August 15, 2014

Raymond McKinley, Jr.  
Chief – Reactor Projects Branch #5  
U.S. Nuclear Regulatory Commission  
2100 Renaissance Blvd., Suite 100  
King of Prussia, PA 19406-2713

# Simplified Gaseous Effluent Flow Diagram Millstone Unit Two

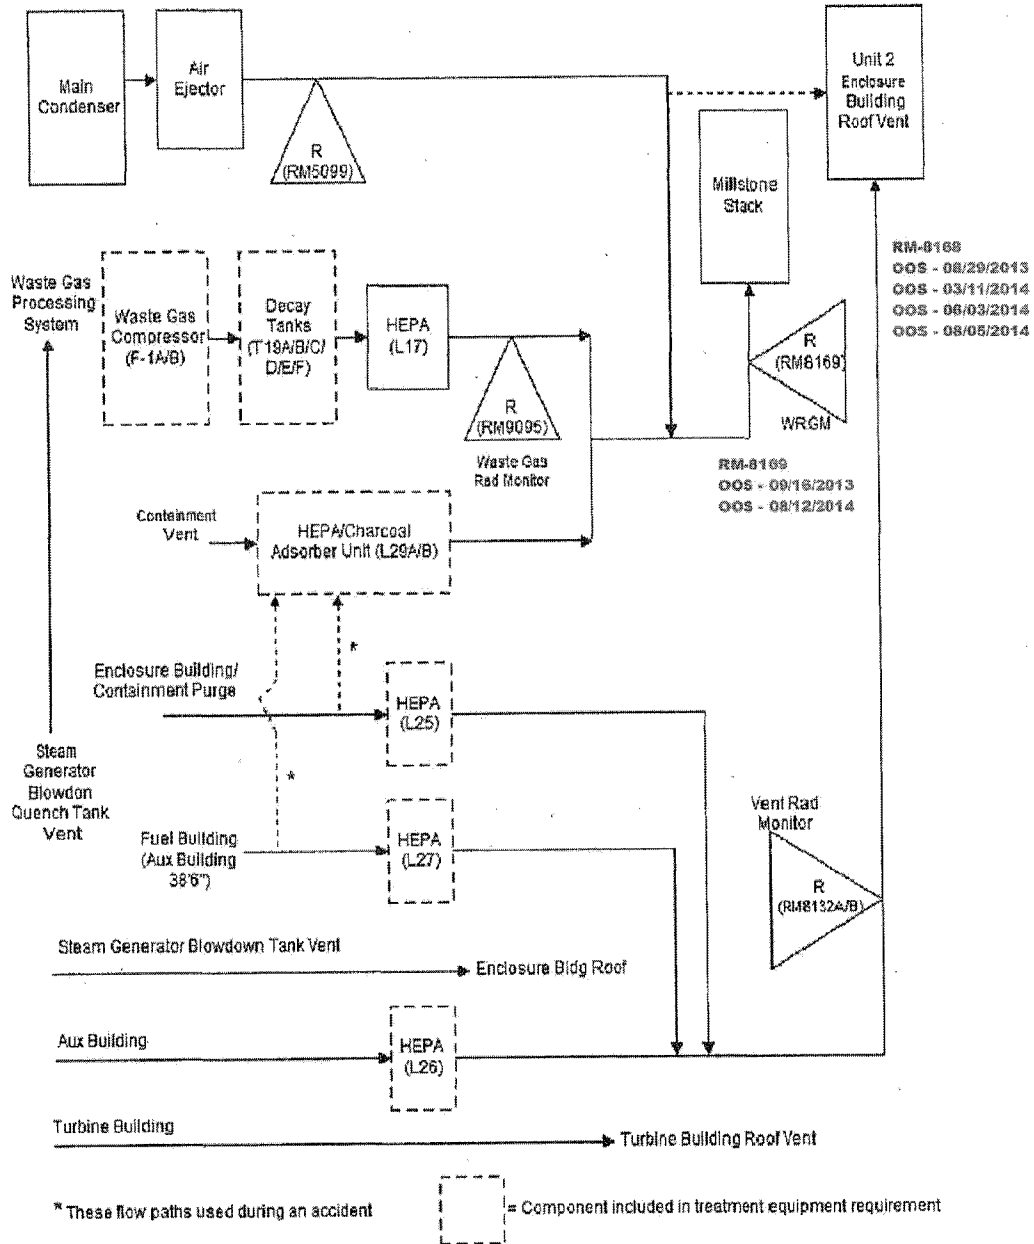
On Millstone Unit 2, the normal stack radiation monitor (RM-8169) has been reported out of service at least twice during the past year. The high range stack radiation monitor (RM-8168) has been reported out of service at least four times during the past year. The enclosure to this letter includes a schematic of the gaseous effluent pathways for Millstone Unit 2 along with the Event Notifications to the NRC about out of service radiation monitors for those release paths.

RM-8169 appears to be governed by the Radiological Effluent Monitoring and Off-site Dose Calculation Manual (REMOCM), specifically Table IV.C.-3 (also provided in the enclosure). Actions B, C, and E apply when RM-8169 is out of service. Collectively, these Actions require flow rates to be estimated every 5 hours, grab samples taken every 12 hours, and auxiliary sampling equipment placed in service within 12 hours.

**Q-2: Did workers at Millstone implement the appropriate compensatory measures within the applicable times as mandated by these actions?**

**Q-3: Since "*There are no compensatory measures to mitigate the degradation or loss of emergency response function if the monitor is inoperable,*" is the NRC comfortable with the recurring out of service periods for this unique safety component? If so, why? If not, what measures will the NRC employ to compel greater reliability of this function?**

RM-8168 is governed by the technical specifications, specifically Table 3.3-6 (provided in the enclosure). Action 17 applies when RM-8168 is out of service and requires an alternate monitoring method be implemented within 72 hours. It is not clear from the publicly available reports whether the monitor outages lasted longer than 72 hours.

**Q-4: How long did the RM-8168 out of service periods last?**

**Q-5: For each out of service period lasting longer than 72 hours, was an appropriate alternate monitoring method placed in service in time?**

# Simplified Gaseous Effluent Flow Diagram Millstone Unit Three

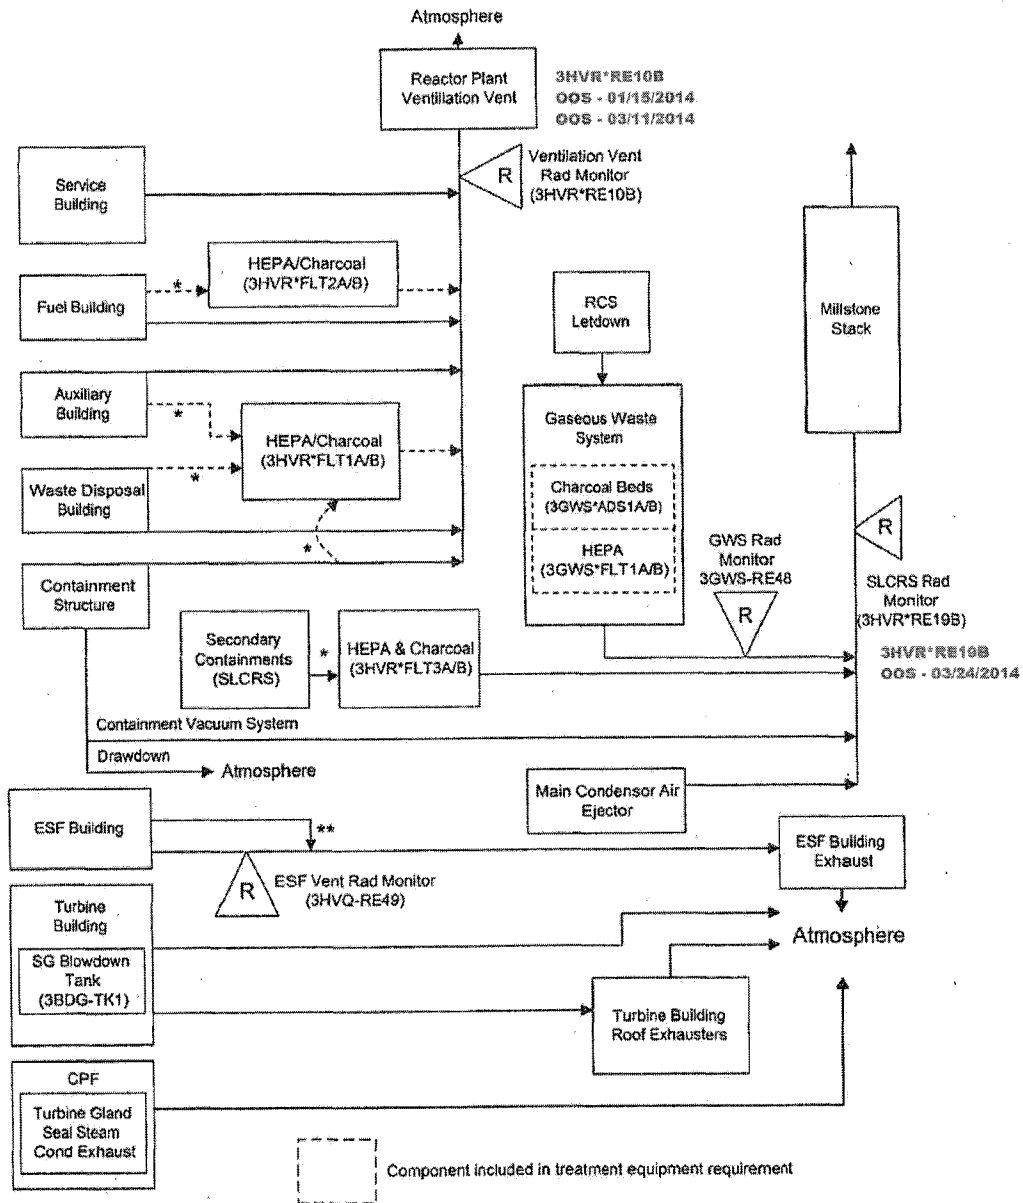
On Millstone Unit 3, the normal stack radiation monitor (3HVR\*RE10B) has been reported out of service at least twice during the past year. The secondary containment ventilation radiation monitor (3HVR\*19B) has been reported out of service at least once during the past year. The enclosure to this letter includes a schematic of the gaseous effluent pathways for Millstone Unit 3 along with the Event Notifications to the NRC about out of service radiation monitors for those release paths.

3HVR\*10B and 3HVR\*19B both appear to be governed by the Radiological Effluent Monitoring and Off-site Dose Calculation Manual (REMDCM), specifically Table V.C.-3 (also provided in the enclosure). Actions A, B, and C apply when either radiation monitor is out of service. Collectively, these Actions require flow rates to be estimated every 5 hours, grab samples taken every 12 hours, and auxiliary sampling equipment placed in service within 12 hours.

**Q-6: Did workers at Millstone implement the appropriate compensatory measures within the applicable times as mandated by these actions?**
